SUBJECT: DISPOSAL OF BYPRODUCT MATERIAL AT AMBROSIA LAKE SITE

Re: Ambrosia Lake Facility  
License SUA-1473, Docket No. 40-8905  
Byproduct Disposal

**QUIVIRA MINING COMPANY  
CLARIFICATION REQUEST  
REGARDING DE-MINIMIS BYPRODUCT DISPOSAL**

**FIGURE 1**  
**GENERAL DISPOSAL CELL CONFIGURATION**

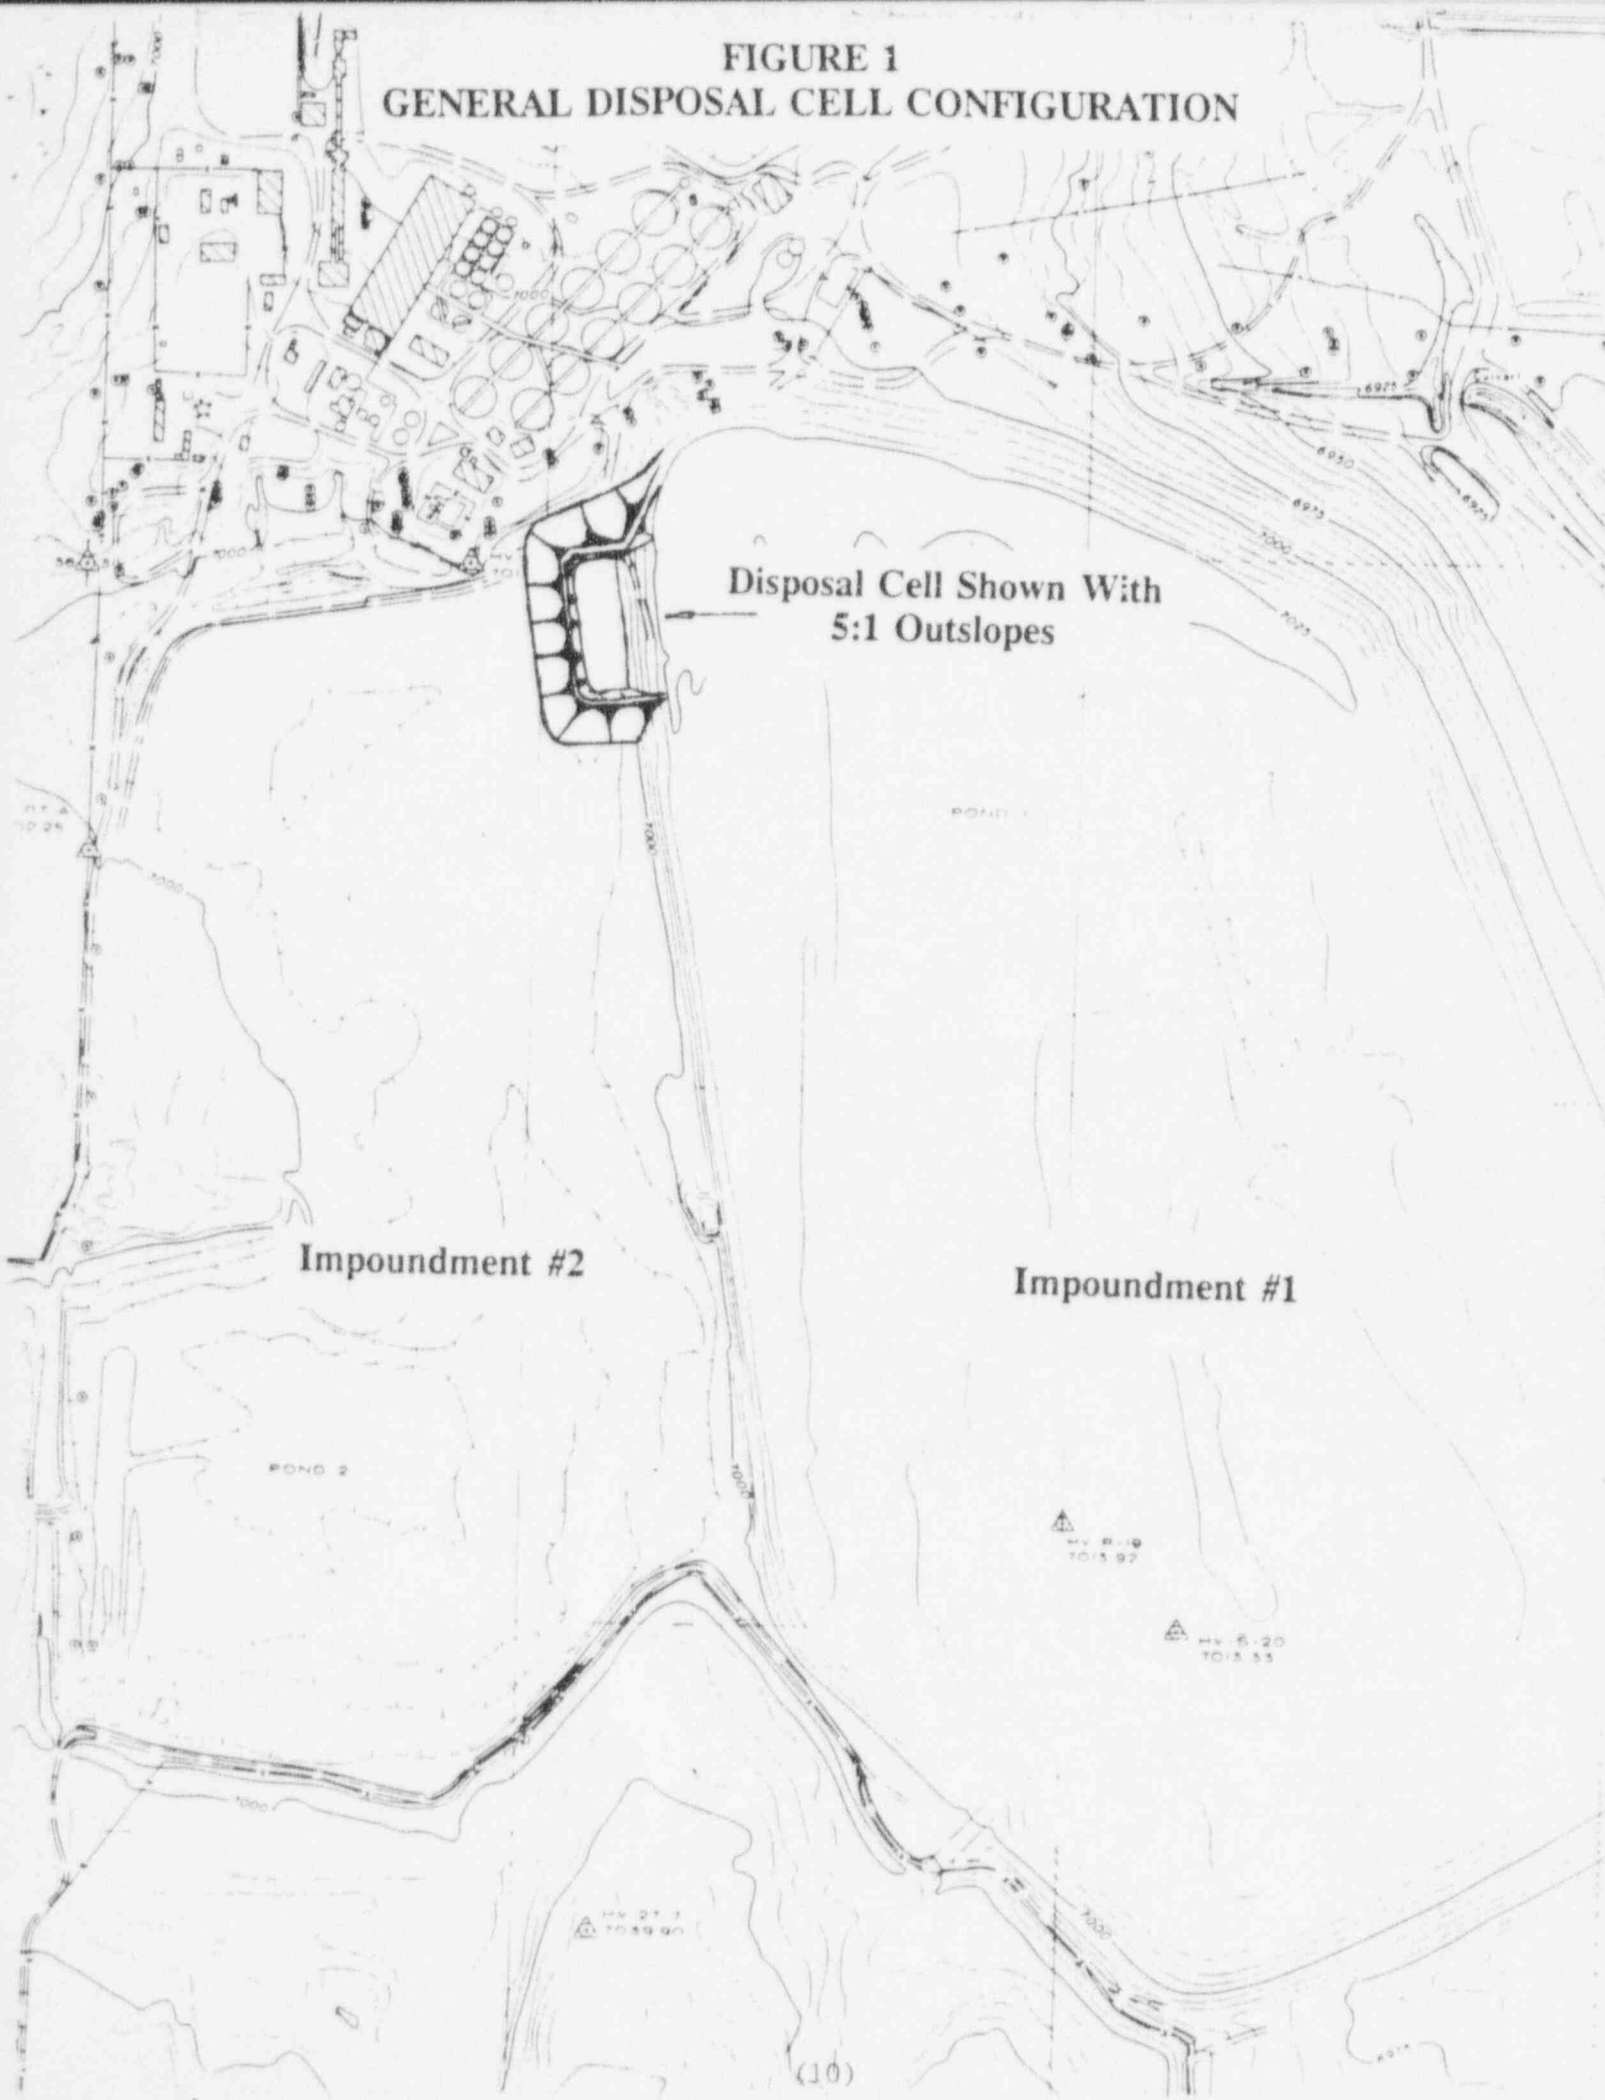
The material being proposed for disposal at the Ambrosia Lake site will be placed in earthen cells constructed on top of the finished NRC approved radon attenuation cover system on impoundment #2. A general disposal cell plot schematic with a final 5:1 outside is shown on Figure 1. The location of the earthen cell(s) will be on the east side of tailings impoundment #2 and abut tailings impoundment #1. For economics considerations during cell construction, the cell will be generally built to contain more than a single de-minimis quantity.
